Advice Note – Stack Height for an Alternative Waste Management Facility at the Rivenhall site

Essex County Council currently has before it a proposal to increase the height of the stack from 35m to 58m, to serve a (yet to be constructed) Integrated Waste Management Facility at the Rivenhall site.

Clear Air Thinking has been asked by BPP Consulting to provide expert advice on the following questions:

Figure 4 – Annual mean PC against Marginal Annualised Cost, showing interception with 45° line

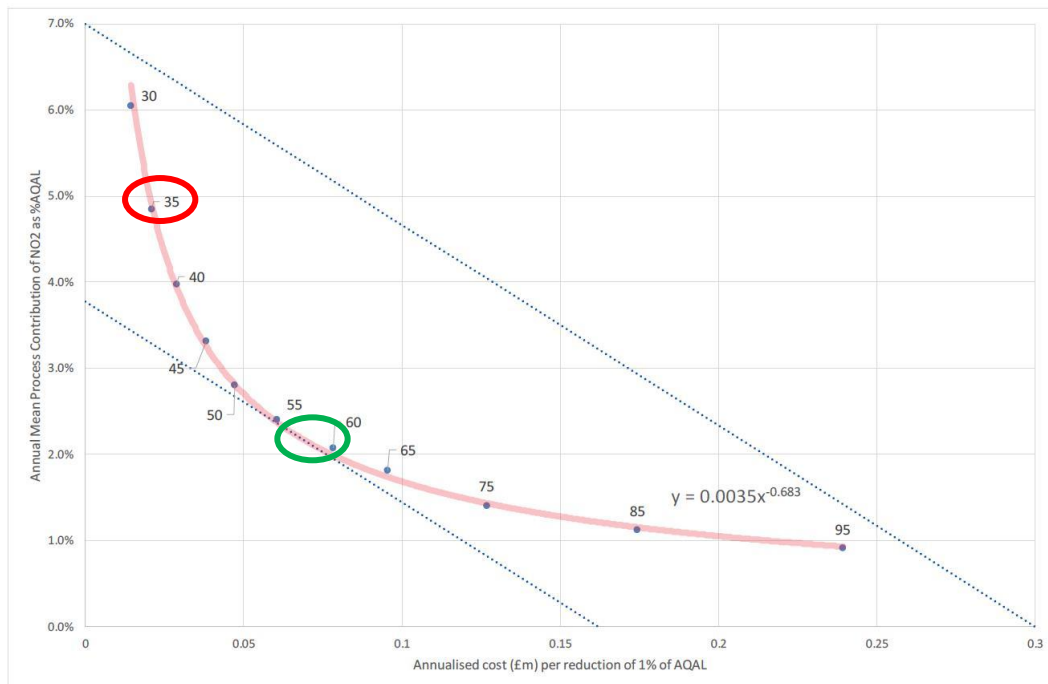
In simple terms, it demonstrates that the marginal cost increases considerably as the stack height increases beyond 60m (where the curve leaves the dotted line to the right) with relatively little, i.e. marginal, additional benefit in terms of emissions reduction (aka process contribution - PC). The analysis presented is considered to provide a reasonable justification for the proposed height of 58m. It also demonstrates that significant improvements in air quality impacts can be achieved by moving from the original height of 35m (red ring) to 58m (green ring) at relatively little additional cost.

It should be noted that this height is viable partly because the applicant conceded to adhere to a significantly lower emission limit for NO_x at it leaves the stack of 150 mg m⁻³ through adoption of selective non-catalytic reduction technology (SNCR) involving addition of ammonia/urea to the flue gas², at additional cost. If they had not conceded that and worked to the limit prescribed by the Industrial Emissions Directive of 200 mg m⁻³, as applies to most similar facilities in the UK, the stack would have needed to be significantly taller still.

Figure 6 –Stack Height (above surrounding ground level) against Throughput

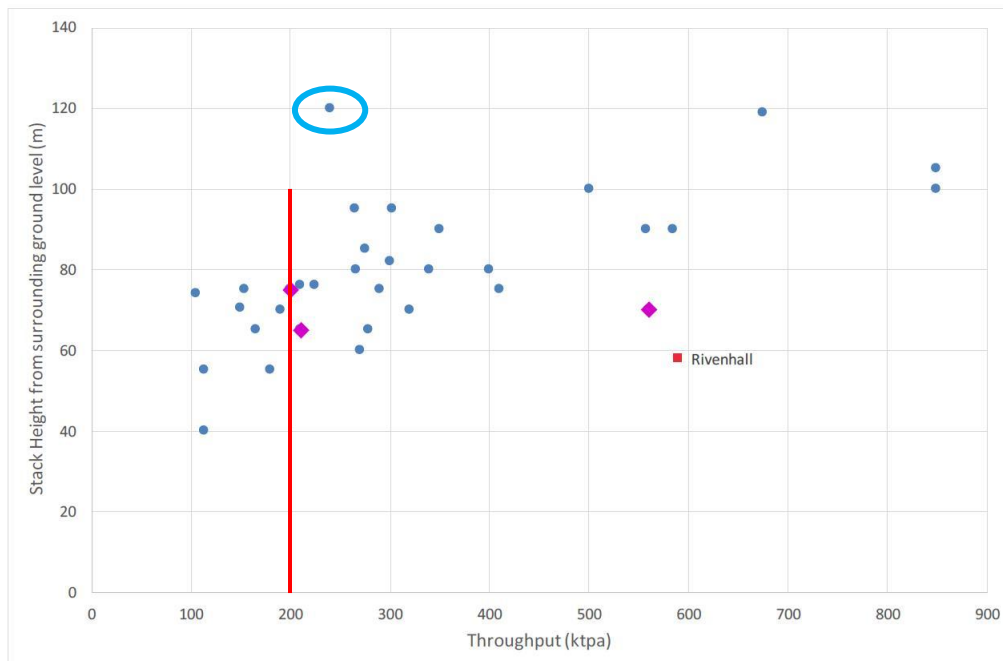
While, in general, stack height increases broadly with throughput, there is a large spread in the data. All these points in the graphical plot are for waste combustion facilities with an Environmental Permit. It is therefore considered that the principles of BAT are reflected in the approved stack heights, i.e. the cost-benefit considerations have been accounted for.

The fact that Rivenhall is shown as an outlier, i.e. has a significantly lower stack height than the majority of plants, reflects the decision to accept a lower emission limit for NO_x in the flue gas. Nearly all the other facilities included here have an emission limit of 200 mg m^{-3} . Other outliers reflect some particular local circumstances. For example, the plant ringed in blue is the Cornwall EfW plant which has a stack height of 120m, with a throughput of 240,000 tonnes per annum, because a nearby Special Area of Conservation required a greater level of protection from nitrogen deposition.

Figure 6 shows that for facilities with a throughput of 200,000 tonnes per annum (as indicated by the red line), stack heights are in a similar range to Rivenhall and above (c55-80 m). Adoption of a lower NO_x emission limit i.e. to 150 mg m^{-3} through adoption of SNCR would mean the stack height of these other plants could have been lower, although by how much is hard to determine given the scatter in the data points and the absence of a clear fit.

Figure 7 – Stack Height against Building Height above ground level

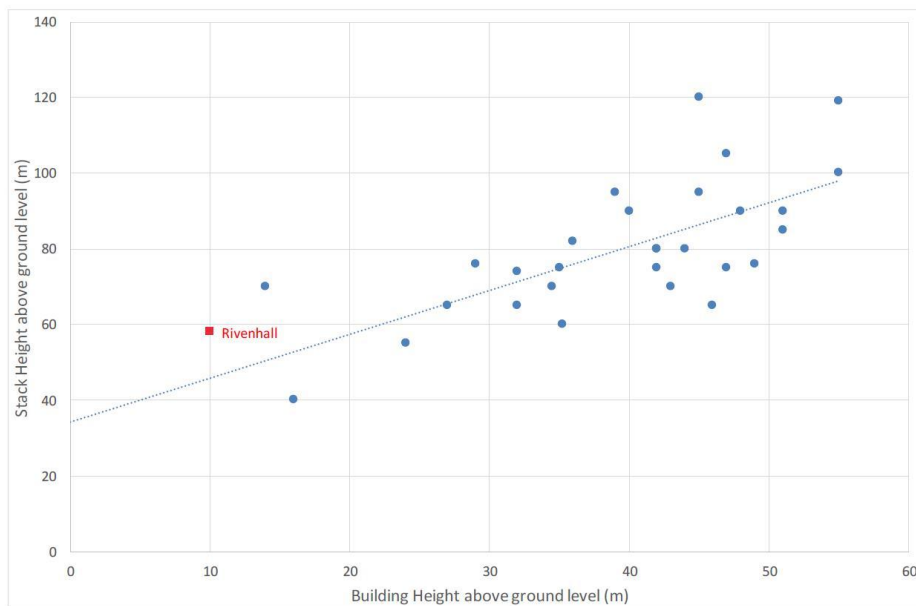
One of the factors that would typically influence the stack height determination is building height, since the building 'downwash' effect on the dispersing plume can increase ground level concentrations considerably. In the case of the current proposal, as for the stack, the building is partially sunk relative to the surrounding land. This reduction in building height relative to the stack is advantageous for dispersion and increases what might be referred to as the effective stack height. The Fichtner analysis has considered the relationship between stack height and building height. This is shown in Figure 7 reproduced overleaf. This shows that while the Rivenhall building/stack height relationship is broadly in line with that of other facilities around the country, the stack is somewhat taller than might be expected for a building of the height proposed.

For any alternative proposal for this site with a reduced throughput, e.g. 200,000 tonnes per annum, it would be reasonable to assume that building height would not be an atypical factor that would distort the stack height determination carried out for Rivenhall.
